Planning Commission Staff Report

Consideration of a Preliminary Plat application for the Whiting Farm subdivision consisting of 70 lots at approximately 800 North 800 West and the adoption of the Planned Residential Community (PRC-7) zoning text.

Development Review Committee Minutes

On November 23, 2020 revised plans were submitted for the Whiting Farm subdivision consisting of 70 lots. The items below include 1) requested changes to the submitted plans, 2) other items required as part of the application and/or 3) informational items regarding city standards.

SHEET NO.
2A

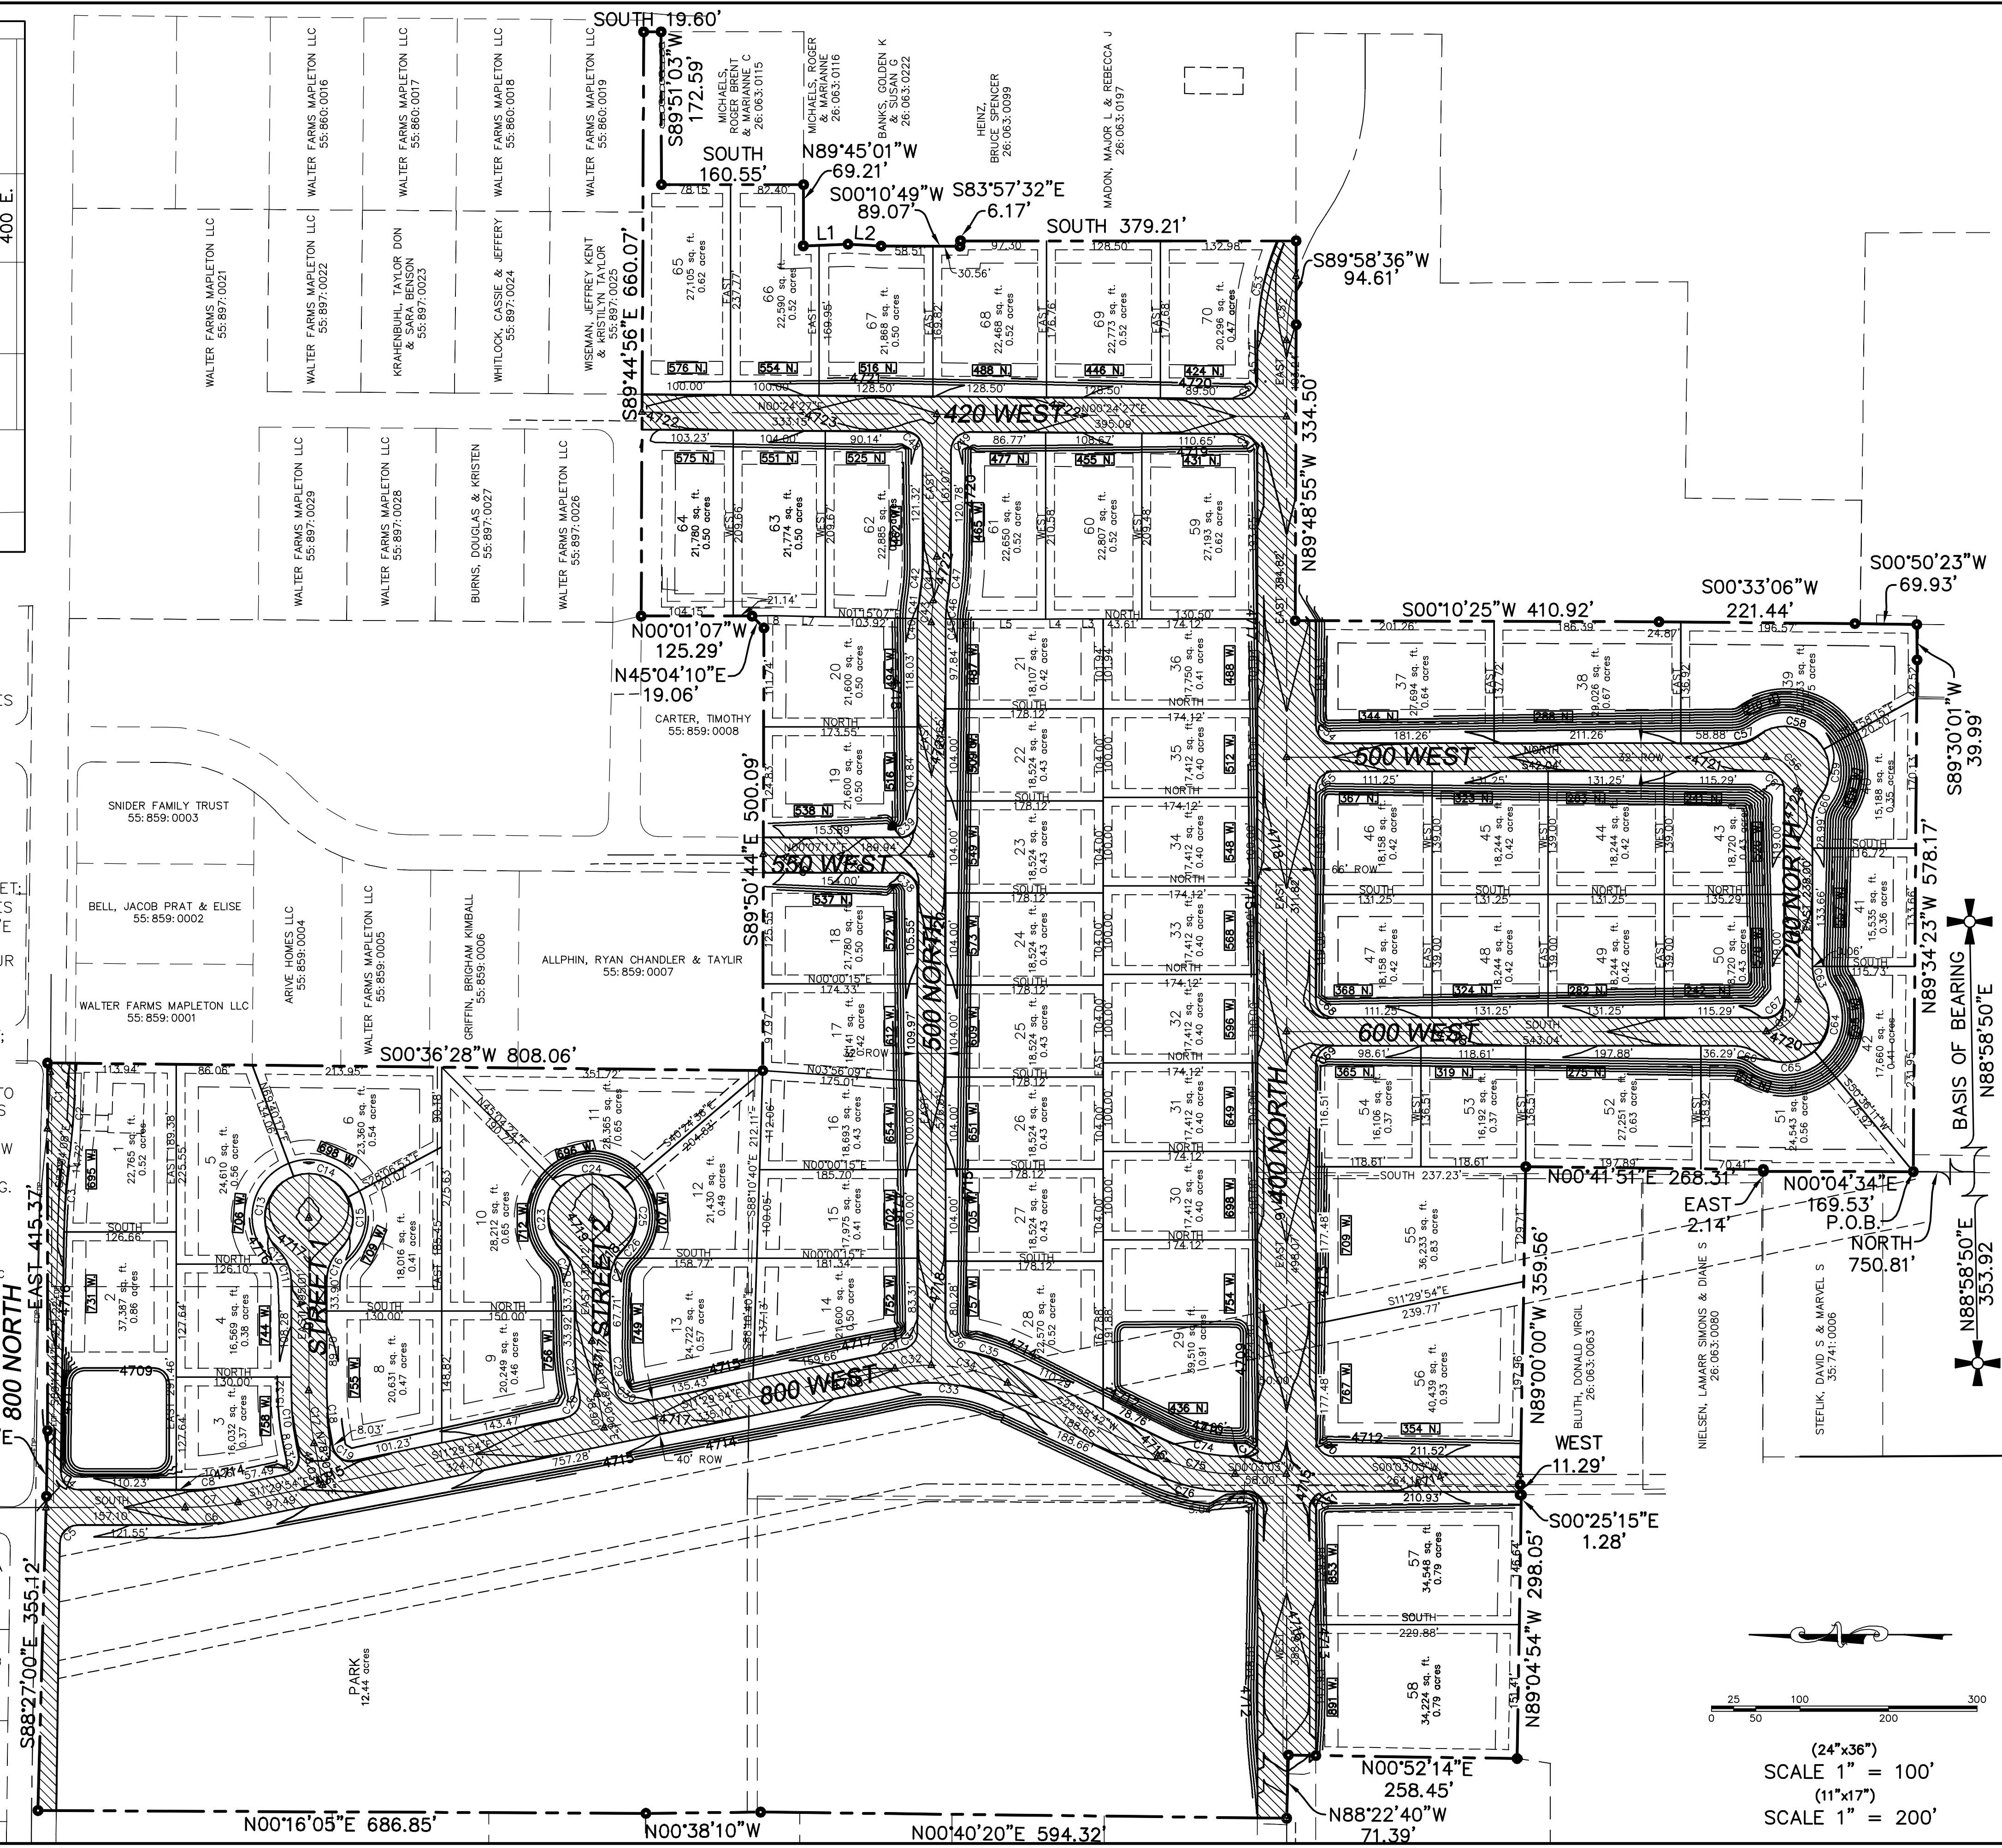
1. 24" HDPE irrigation pipe must be placed in an easement in favor of the irrigation company.
2. C32 is too tight, please adjust to minimum 250' to meet Collector Street standards
